APPEAL SUMMARY

Appeal ID: 20276

Project Address: 4435 NE Campaign St

APPEAL INFORMATION SHEET

Firewall Detail

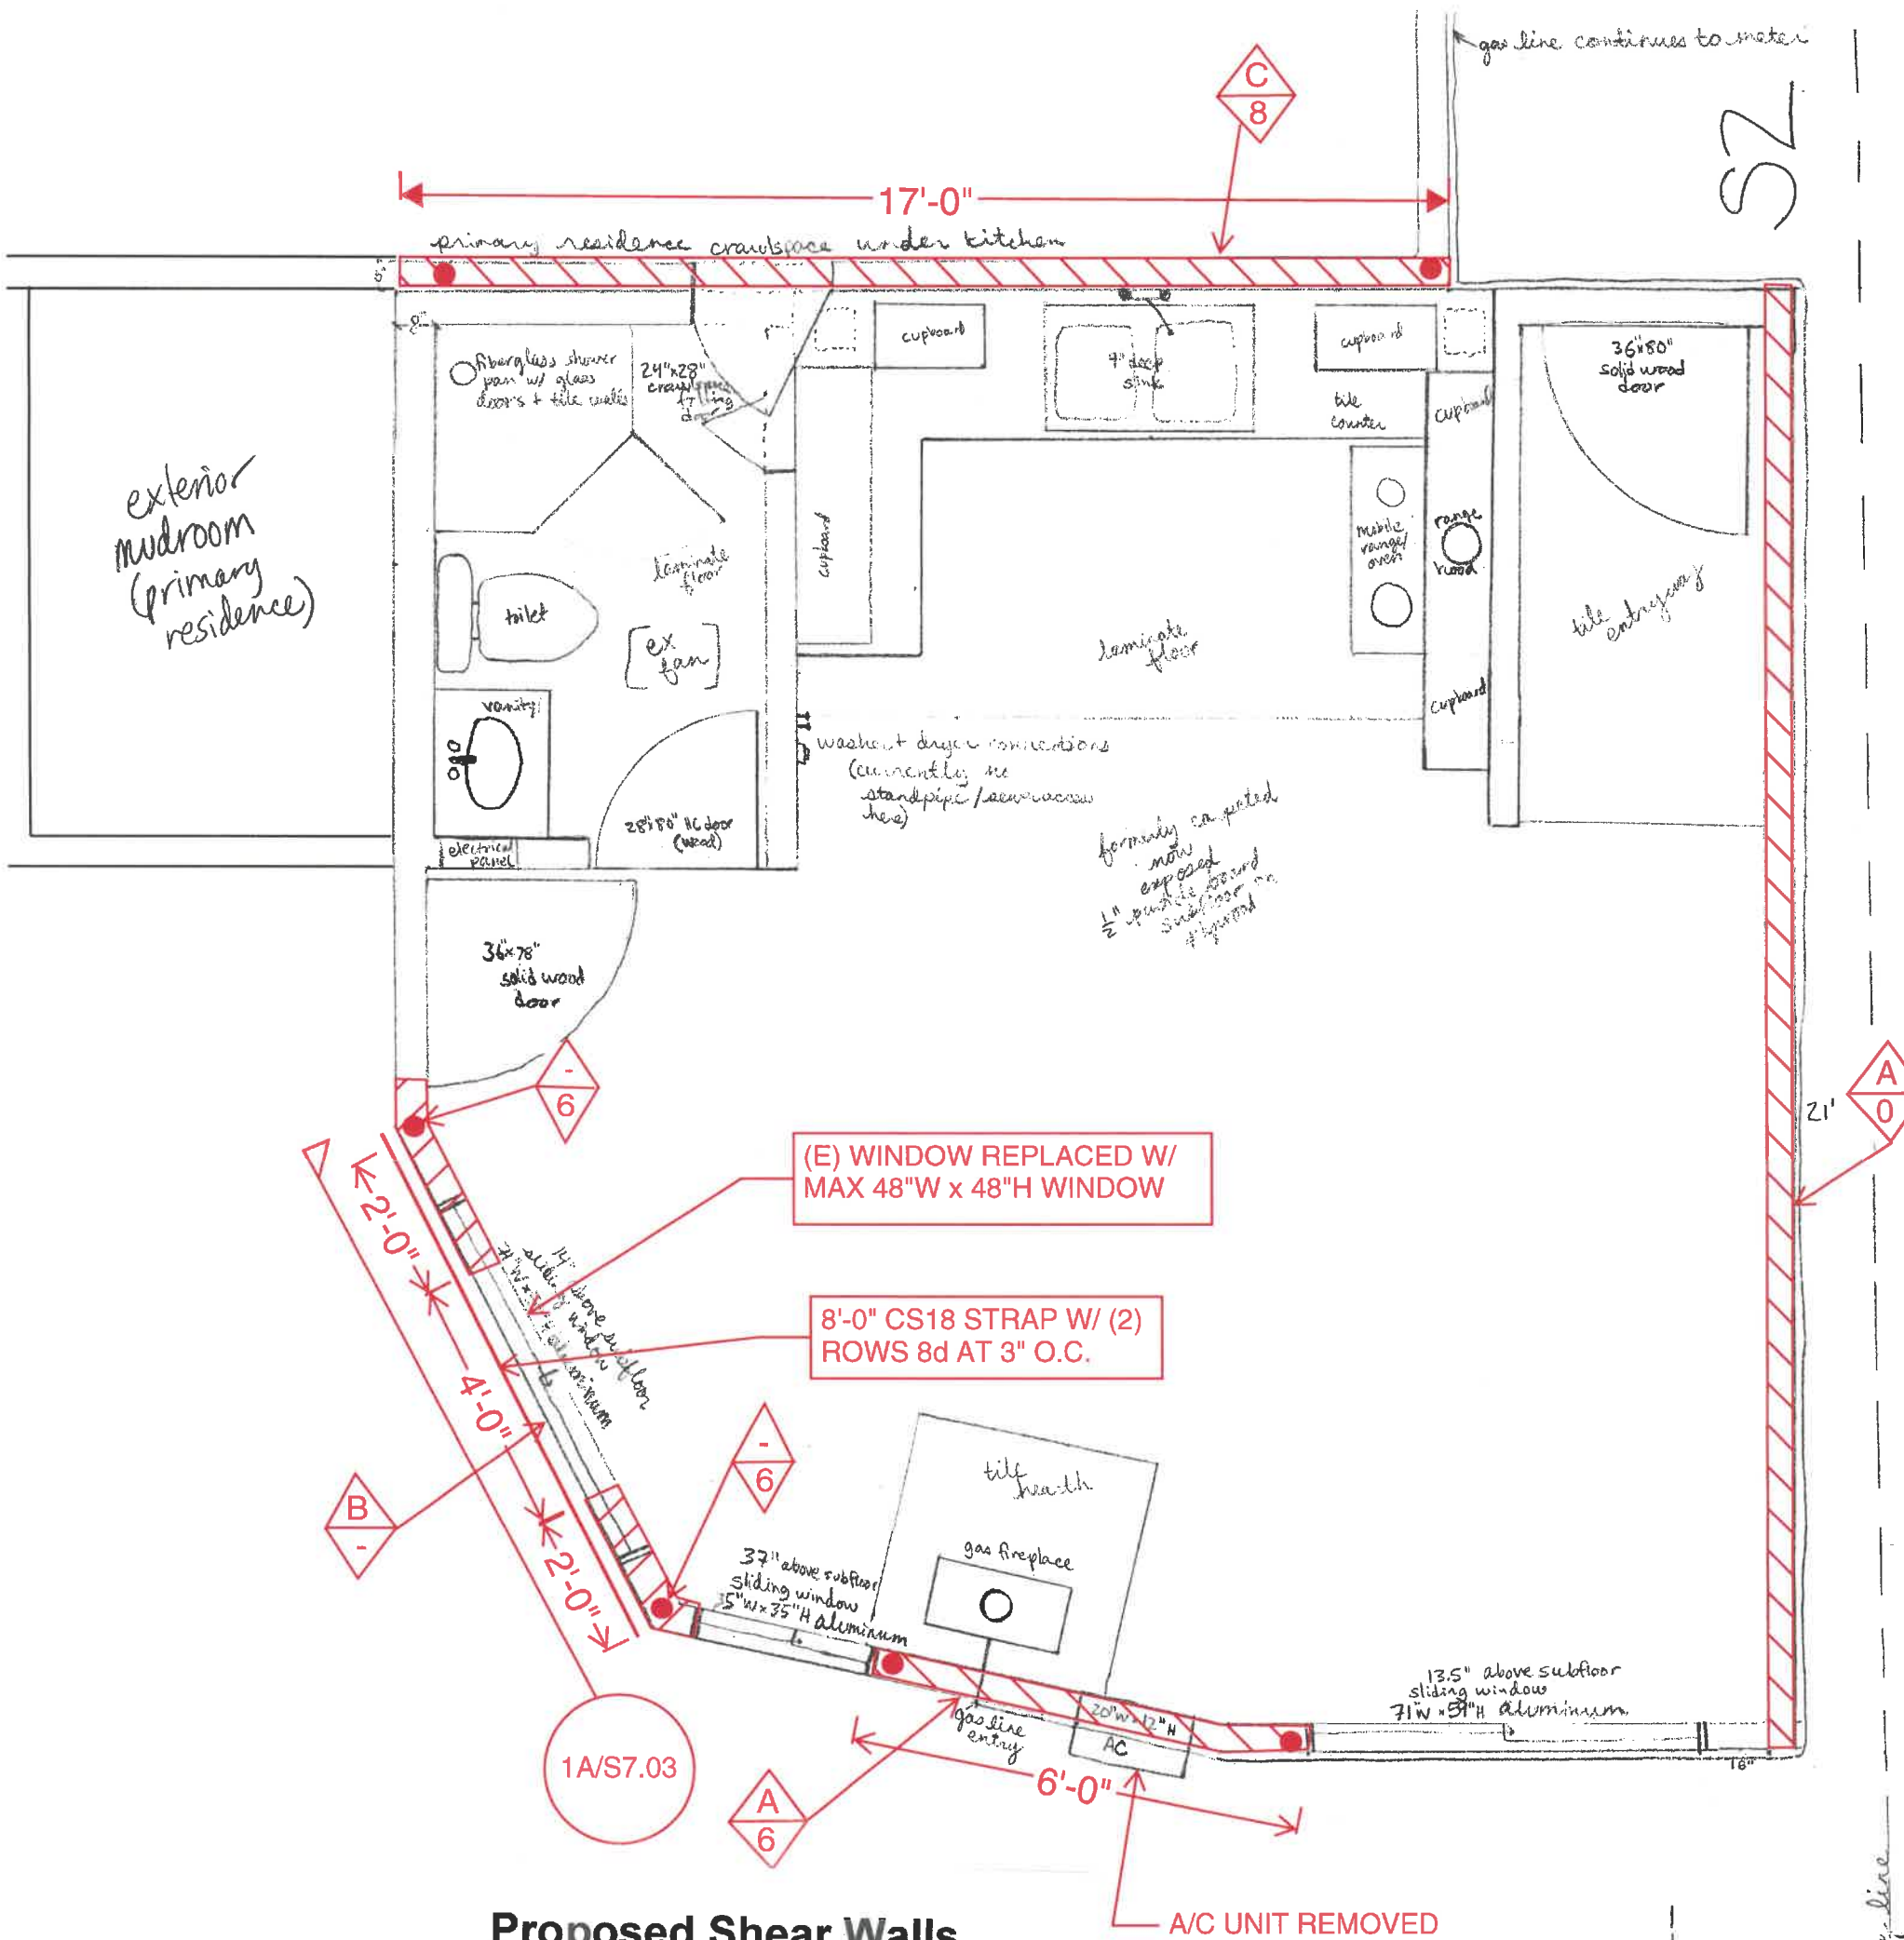
Appeal to modify GA File No. WP 3242 for interior firewall, wood framed.

This firewall assembly to be used on common wall, from foundation stem wall to roof sheathing of ADU.

- One layer $\frac{1}{2}$ " CDX attached to studs as required in engineer's shear wall plan. Resilient channels attached at right angles to 2x4 wood studs 16" OC with $1\frac{3}{4}$ " Type S drywall screws. One layer $\frac{5}{8}$ " type X gypsum wallboard applied at right angles to channels with 1" Type S drywall screws 8" OC with vertical joints located midway between studs. Appeal for additional layer of $\frac{5}{8}$ " type X gypsum wallboard applied with 6d cement coated nails to same side of wall.

- Pre-existing gypsum removed along dotted line.
- 3" Mineral wool inserted into cavity, continuous from foundation stem wall to roof line.

- Pre-existing gypsum removed along dotted line.
- 3" Mineral wool inserted into cavity, continuous from foundation stem wall to roof line.
- One layer $\frac{1}{2}$ " CDX attached to studs as required in engineer's shear wall plan. Resilient channels attached at right angles to 2x4 wood studs 16" OC with $1\frac{3}{4}$ " Type S drywall screws. One layer $\frac{5}{8}$ " type X gypsum wallboard applied at right angles to channels with 1" Type S drywall screws 8" OC with vertical joints located midway between studs. Appeal for additional layer of $\frac{5}{8}$ " type X gypsum wallboard applied with 6d cement coated nails to same side of wall.

- Resilient channels attached at right angles to 2x4 wood studs 16" OC with $1\frac{1}{4}$ " Type S drywall screws. One layer $\frac{5}{8}$ " type X gypsum wallboard applied at right angles to channels with 1" Type S drywall screws 8" OC with vertical joints located midway between studs. Appeal for additional layer of $\frac{5}{8}$ " type X gypsum wallboard applied with 6d cement coated nails to same side of wall.

A 1.5-hr fire-resistant rated, self-latching, gasketed door will be installed in the existing cut out into the primary residence kitchen crawlspace. UL + ULC-rated.

Alternate 1 hour fire rated wall assembly: Granted as proposed.

Firewall Detail

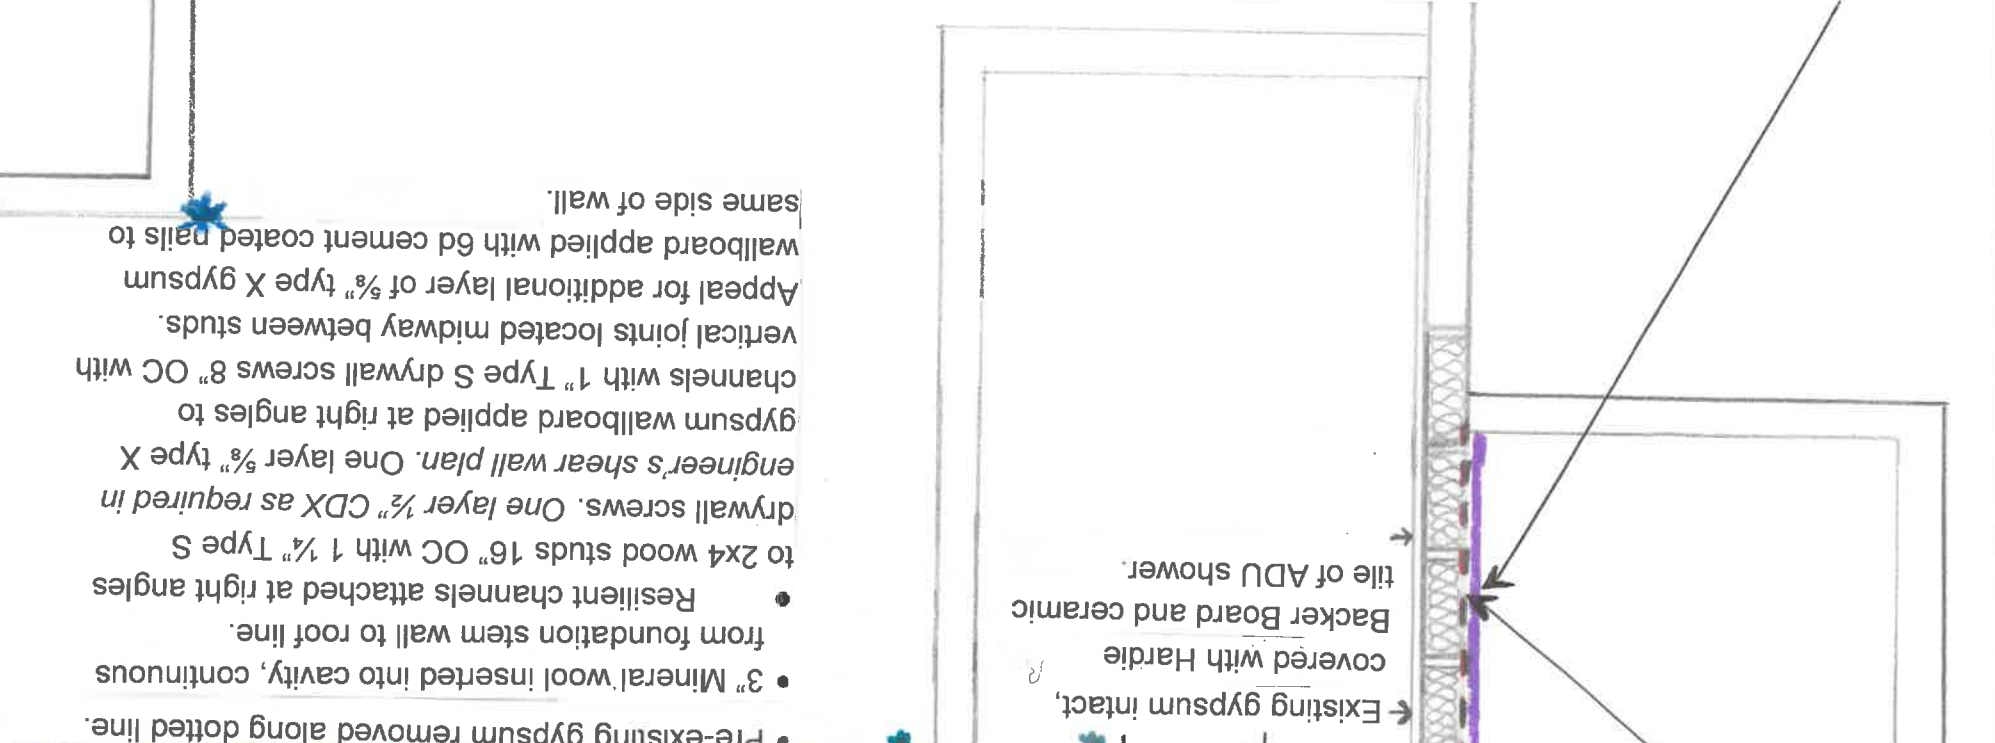
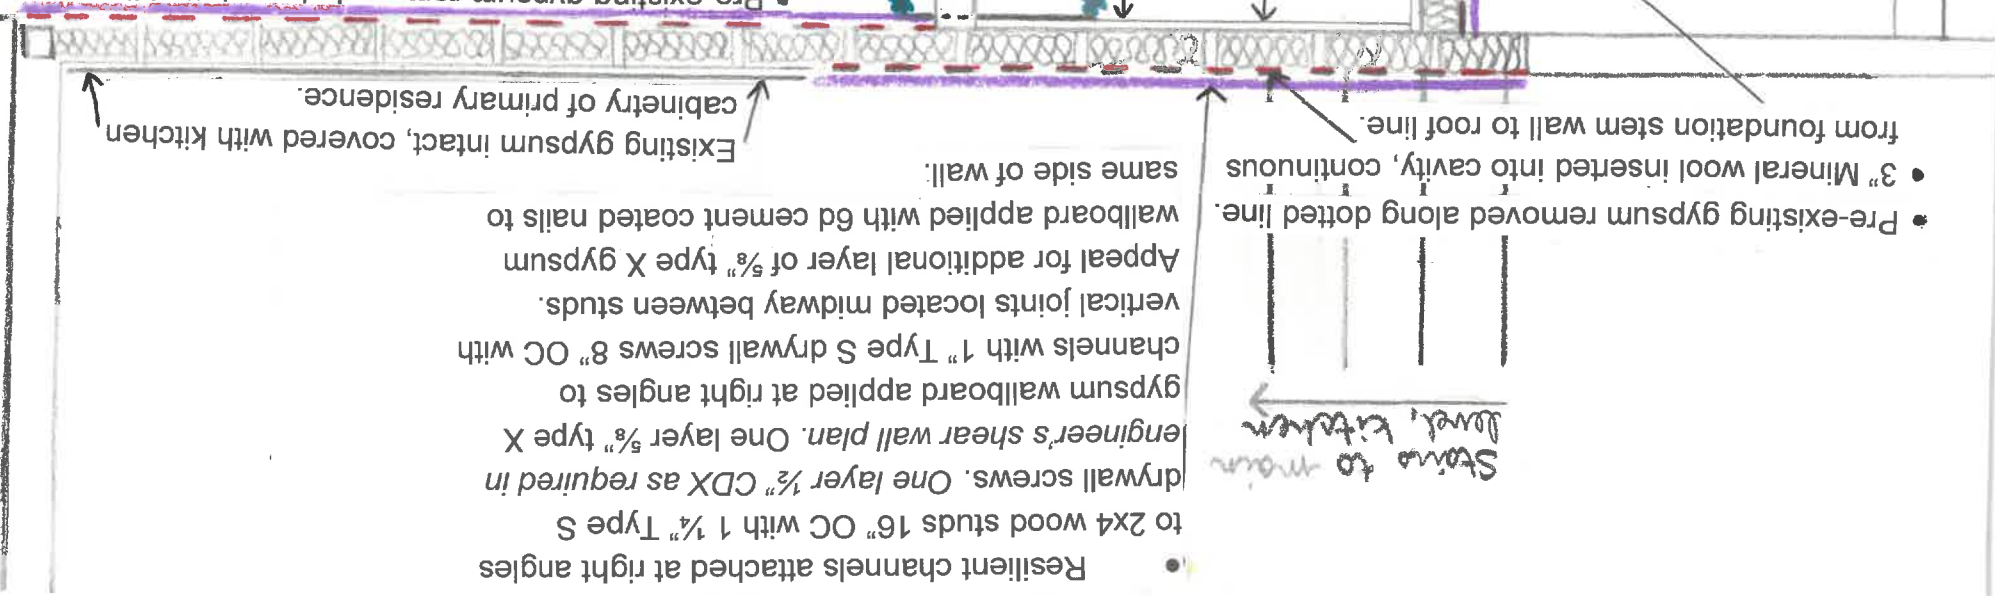
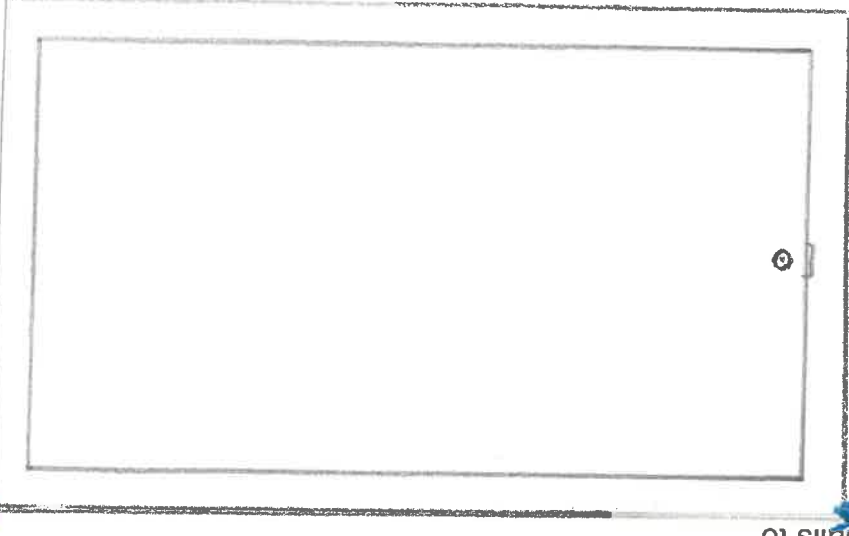
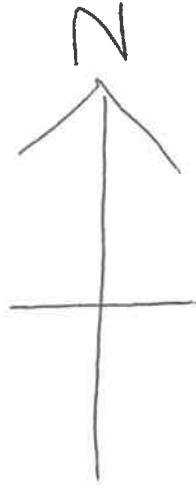
Appeal to modify GA File No. WP 3242 for interior firewall, wood framed.

This firewall assembly to be used on common wall, from foundation stem wall to roof sheathing of ADU.

- Resilient channels attached at right angles to 2x4 wood studs 16" OC with 1 1/4" Type S drywall screws. One layer 5/8" type X gypsum wallboard applied at right angles to channels with 1" Type S drywall screws 8" OC with vertical joints located midway between studs. Appeal for additional layer of 5/8" type X gypsum wallboard applied with 6d cement coated nails to same side of wall.

A 1.5-hr fire-resistant, self-latching gasketed door will be installed in the existing cutout into the primary residence kitchen area. UL + ULC-rated.
